Interactive comment on “Technical Note: Oxygen Optodes on Profiling Platforms: Update on Response Times, In-Air Measurements, and In-Situ Drift” by Henry C. Bittig and Arne Körtzinger

Henry C. Bittig and Arne Körtzinger

Received and published: 15 December 2016

Fig. 2.

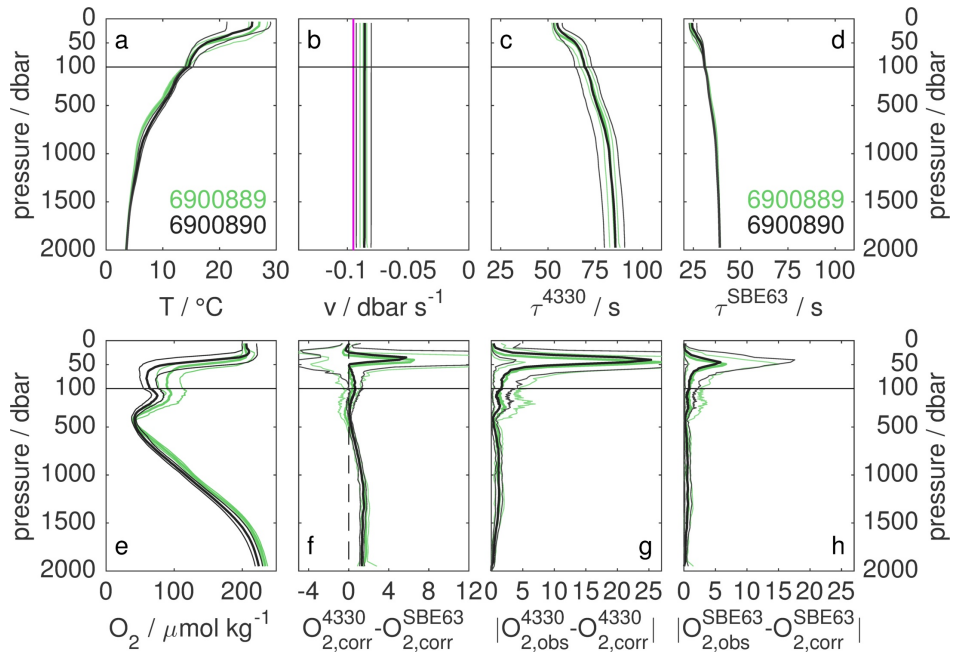
Question about the time stamp: Since most Argo data (that I know of) does not include the time stamp for each measurement, would it be at all useful to estimate a time response correction based on typical ascent speed and the pressure of each sample? I recognize that due to changes water density the ascent speed will not remain constant (as pointed out in the text and figure 3b), but perhaps that can be estimated as well, given knowledge about the float's volume and mass. My point is, you have convincingly demonstrated the need to adjust optode oxygen to account for response times, but is there a way to correct data that does not have a measurement-specific time

stamp and what would be the increase in uncertainty? This might be of great value to other researchers if it is possible.

To assess whether an estimated time is helpful, we took the start and end time of the profile observations and assumed a constant ascent velocity to "re-estimate" the Aanderaa optode 4330 time stamps. The result is shown below in figure 2 (Same as manuscript figure 3 but assuming a constant ascent velocity between profile start and end time (panel b) and recalculating the Aanderaa 4330 optode time stamps accordingly.). The main difficulty we see is less in the estimation of the response time but in the lack of knowledge when a specific measurement was actually taken (assuming pressure-initiated sampling, not frequency-based). In our experiment, the slow down near the pycnocline is not adequately taken into account (i.e., optode samples are estimated closer in time together than they actually are and the response time is estimated to be faster). Both effects are somewhat compensating, so that the median difference between both optodes in the strongest gradients is around $7 - 8 \mu\text{mol kg}^{-1}$ (compared to $2 - 3 \mu\text{mol kg}^{-1}$ with proper time stamps and $13 - 17 \mu\text{mol kg}^{-1}$ without any time response correction). Moreover, we see a consistent over-correction in our case, that can cause a significant bias (90-percentile reaches up to $35 \mu\text{mol kg}^{-1}$).

Given these caveats incl. the potential for serious bias, the results are still surprisingly promising. With a more advanced estimation of the ascent speed, e.g., through some sparse timing information from the log / trajectory file, such time response corrected data appear more adequate than uncorrected data.

Fig. 3.

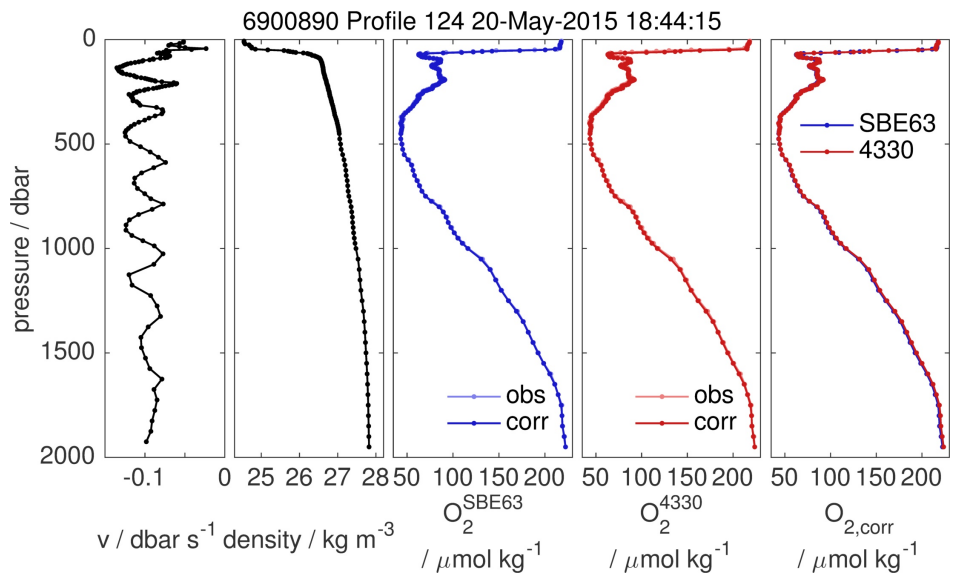
Figure 3b/c – What causes the wavelike fluctuations in ascent speed and response time of the Aanderaa optode between 100 and 1500 db?

The wavelike fluctuations in ascent speed are caused by the float operation: To ascent, the float increases its buoyancy by moving its piston and thus increasing the volume of its external oil bladder. When the ascent speed falls below a certain threshold, the buoyancy is re-adjusted by moving the piston again, causing the float to re-accelerate. Some Argo Data Centers do record these piston buoyancy actions in the respective float tech files. This feedback cycle repeats itself about half a dozen times between 1800 and 300 dbar in our case, see an individual profile of float 6900890 below in figure 3 (same as manuscript figure 2 but to full depth).

In fact, the intermediate and deep density structure seems to be so stable, that these buoyancy actions occur at similar depths for all profiles, which causes them to appear

as said wavelike structure in the median velocity profile.

Fig. 4.

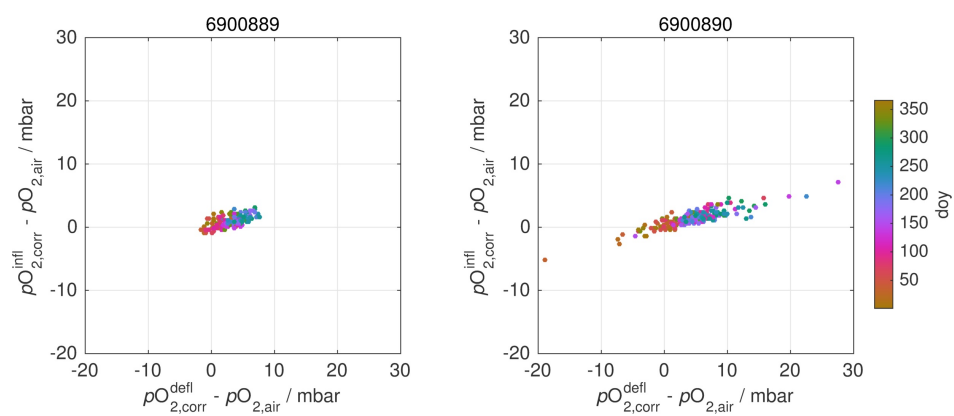
Variable carry over slope? I think from equations 7 and 9, $mt=0$ is constant, and based on the carry over slope determined from the entire deployment. The carry over slope must vary seasonally and potentially interannually, if the float moves far enough. Is it possible to split the deployment into periods of time with different carry over slopes or fit the carry over slope to some type of function of season or time?

To clarify the equations, the carry over slope is only an intermediate fitting parameter to account for secondary effects of the float "in air" measurements (equation 8). The carry over slope c is not used to correct the data. Data are corrected by the oxygen correction factor m_i for each profile i (equations 7 and 9). However, the reviewer is insofar correct that requiring a constant carry over slope c imposes some implicit constraints on the other fit parameter (equation 8), i.e., both the initial oxygen correction factor $m_{t=0}$ and the drift rate a (equation 7). In our data, we have no indication of a variable carry over slope (e.g., figure 4 below).
